STAFF REPORT

APPLICATION RZ/FDP 2014-BR-009

PROPOSAL: The applicant seeks to rezone 8.08 acres from R-1 to PDH-3 to permit the development of 17 single family detached dwelling units at an overall density of 2.1 du/ac.

CONCEPTUAL DEVELOPMENT PLAN / FINAL DEVELOPMENT PLAN
BURKE JUNCTION
 FAIRFAX COUNTY, VIRGINIA

Graphic 1: Proposed Site Layout

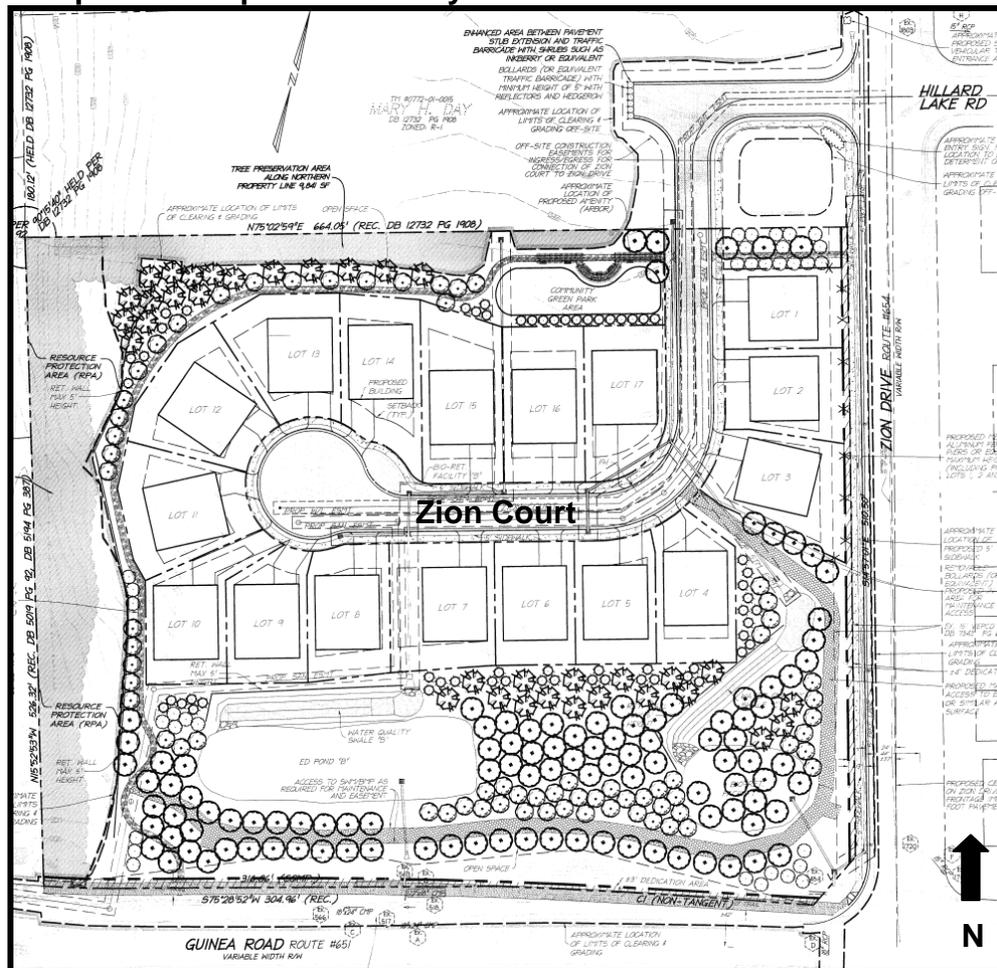
As shown on the graphic, 17 single-family detached dwelling units would be constructed along both sides of a new private road (shown as Zion Court). This new private road would begin off-site on Tax Map 77-2 ((1)) 15 to the northeast across from Hillard Lake Road and terminate in a cul-de sac on the western portion of the subject property. An ingress/ egress easement has been secured with the property owner to the north (Tax Map 77-2 ((1)) 15) to allow construction of the private road entrance. The applicant proposes to construct this private road to meet public street standards and to allow for on-street parking for visitors within a 29-foot wide cross street section, as well as future interparcel connection/access for properties to the north.
